# NEWMAR CORPORATION WARRANTY DEPARTMENT

|   | T         | ECHNICAL  | SERV         |   | FTIN |       |      |
|---|-----------|---|--------------|---|------|-------|------|
| 7/28/08   |           | 2007 – 2008   |              | All on Spartan K2 & K<br>chassis w/ Hadley SL |      | 3 349 |      |

## **CAMPAIGN SERVICE BULLETIN**

<u>SUBJECT</u>: Air Supply System – Hadley<sup>®</sup> SLS (Self Leveling System) Ride height Control

### HADLEY® JACK INTERFACE CONTROL MODULE FIG. 2-1

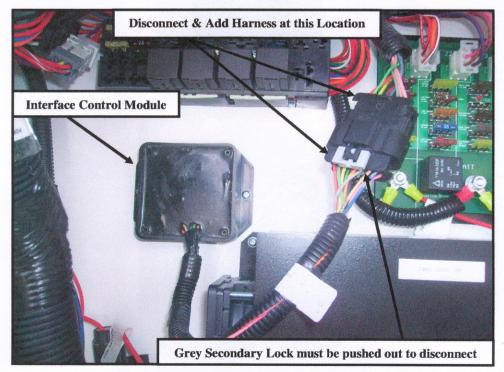
- <u>APPLIES TO</u>: Certain Spartan K-2 & K-3 Chassis produced for Newmar & Tiffin equipped with a Hadley<sup>®</sup> SLS ride height control system and having a VDM (Vehicle Date of Manufacture) of April 18, 2007 through June 26, 2008.
- **<u>CONDITION</u>**: Potential for chassis not to be at proper ride height.

**CORRECTION:** Incorporate a diode harness

- 1. Observe all industry safety standards, disconnect any necessary power source and secure vehicle for adding an additional harness to the Hadley<sup>®</sup> ride height electrical system.
- 2. Refer to FIG. 2-1. Locate the Hadley<sup>®</sup> Jack Interface Control Module. The module is typically mounted at left front corner of vehicle, either on front bulkhead or in a driver side front compartment.
- 3. Refer to FIG. 2-1 & 3-1. Trace wires from interface control module to the 16-way connector (approximately 12").
  - 3a. Slide grey secondary lock out, to disconnect connector, and re-connect appropriate connector end into each side of new harness from kit.
  - 3b. Slide grey secondary lock in, to secure harness connections.
